Work Order ID 83763

Item Name: Replacement Skidtube

DRAWING NO. D2580	TITLE 205 SKIDTUBE ASSEMBLY	REV. E	DART AEROSPACE LTD ENGINEERING ORDER	D.E.O. NO. D2580-E-1	SHEET NO. SHEET 1 OF 1	SCALE NTS
DRAWN <i>UP</i>	CHECKED <i>ASS</i>	MFG. APPR. <i>ER</i>	APPROVED <i>[Signature]</i>	DE APPR. <i>[Signature]</i>		
DATE 11.12.13	DATE 11.12.13	DATE 11.12.13	DATE 11.12.13	DATE 11.12.13	DATE 11.12.13

CHANGE ALL C'BORED WELDED CROSSBOLT SPACERS TO SWAGED SPACERS

SECTION B-B, SECTION F-F, & SECTION I-I ARE AMENDED AS FOLLOWS
FOR ALL HOLES THAT WERE ORIGINALLY C'BORED:

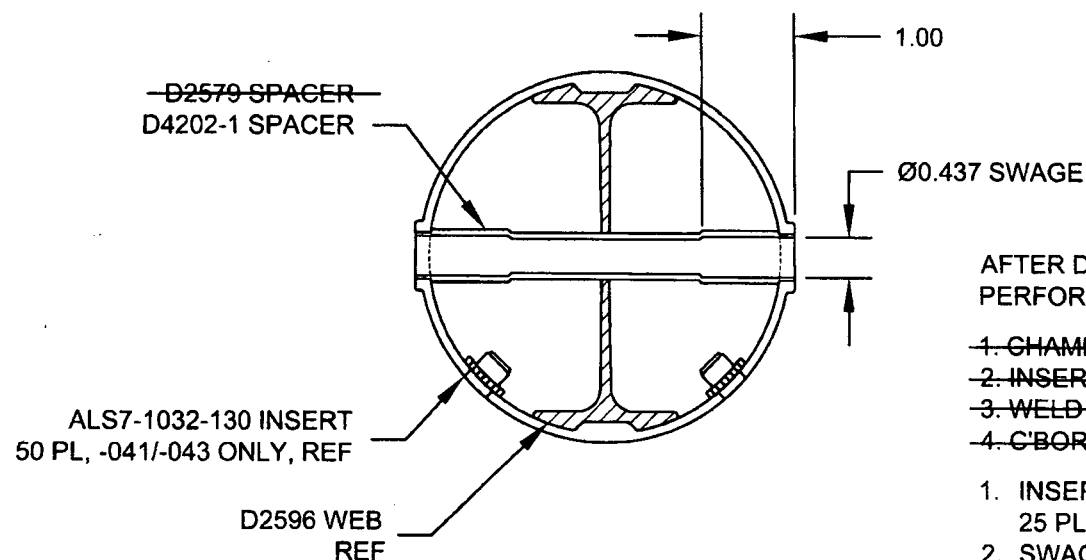
PARTS LIST IS AMENDED AS FOLLOWS:

WAS

QTY	QTY	QTY	PART NUMBER	DESCRIPTION
-041	-045	-047		
20	24	25	D2579	CROSS BOLT SPACER

AFTER DRILLING AND BENDING ASSEMBLY
PERFORM THE FOLLOWING FOR Ø0.508 HOLES ONLY:

1. CHAMFER HOLE 0.060 X 45°
2. INSERT D2579 SPACER (20 PLACES)
3. WELD INTO PLACE AND GRIND FLUSH
4. C'BORE D2579 SPACER TO Ø0.437 X 1.00 DEEP

IS

4		* D2579	CROSS BOLT SPACER
20	20	25	D4202-1	SPACER

WELD 4X D2579 SPACERS PER DWG
IN LOCATIONS MARKED "NO C'BORE".
REF SHEET 4 OF DWG.

1. INSERT D4202-1 SPACER, 20 PL (-041) OR 20 PL (-045) OR 25 PL (-047)
2. SWAGE TO Ø0.437 X 1.00 DEEP PER QSI 002
3. TRIM / GRIND FLUSH PER QSI 002
